#### LISIEUX PARK

#### South Elevations Permitted & Proposed

<b>Stage</b> Planning		<b>Drawn</b> SR		<b>FF</b> FF		<b>Rev</b> P01
<b>Project Code</b> 6275		<b>Job</b> LIS	<b>Origin</b> BKD	<b>Zone</b> ZZ	<b>Level</b> DR	<b>Sheet no.</b> A- 2003

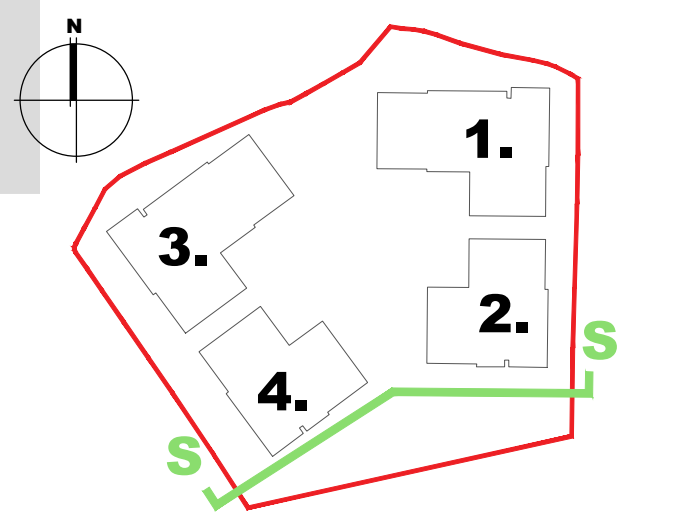
- (1) ALL PERMITTED BEDROOM DOORS  
OPENING ON TO BALCONIES  
CHANGED TO WINDOWS TO IMPROVE  
SAFETY AND SECURITY.
- (2) PERMITTED GLAZED ATRIUM AT ROOF  
LEVEL (ABOVE STAIR AND LIFT CORE)  
REMOVED FOR FSC PURPOSES
- (3) GLAZED LINK CORRIDORS BETWEEN  
BUILDINGS REMOVED
- (4) WINDOWS TO WC SHOWER AREA  
OMITTED FOR PRIVACY
- (5) MINOR CHANGES TO FENESTRATION  
TO ACCOMMODATE IMPROVED  
APARTMENT LAYOUTS
- (6) NON-STRUCTURAL COLUMNS  
OMITTED FROM BALCONIES TO  
IMPROVE DAYLIGHT INTO  
APARTMENTS
